Intel[®] Atom[™] Processor E6xx Series

Specification Update

May 2013

Revision 016

Figure 10. 1U Natural Convection Heatsink Mechanical Drawing

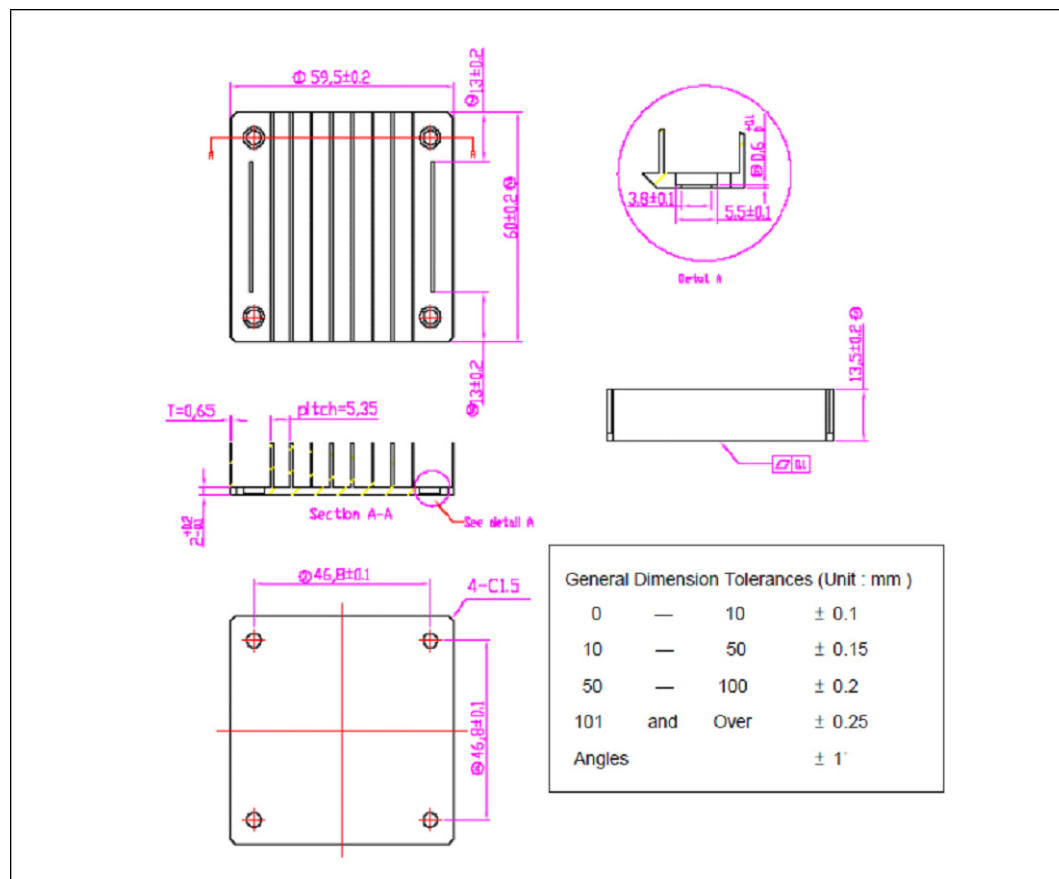
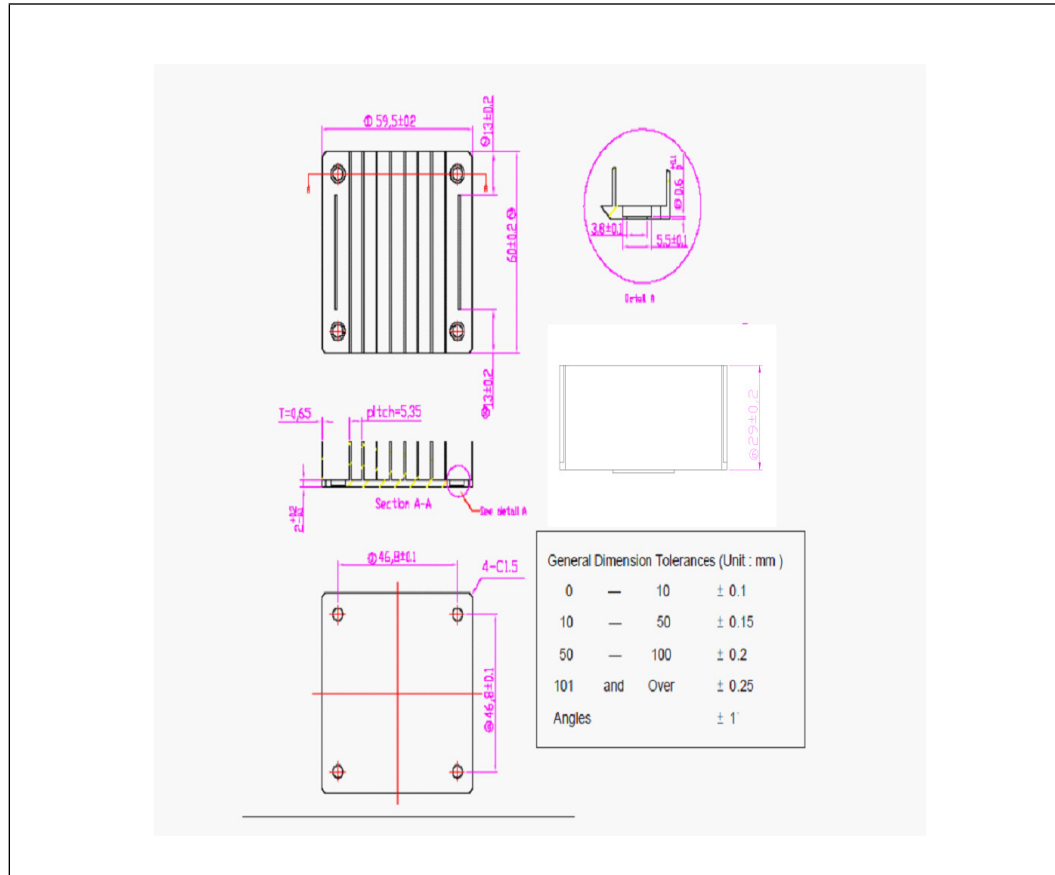
1. Heatsink Height Change

Issue: Heatsink height on Figure 10 "1U Natural Convection Heatsink Mechanical Drawing" has changed from 13.5 ± 0.2 mm to 29 ± 0.2 mm.
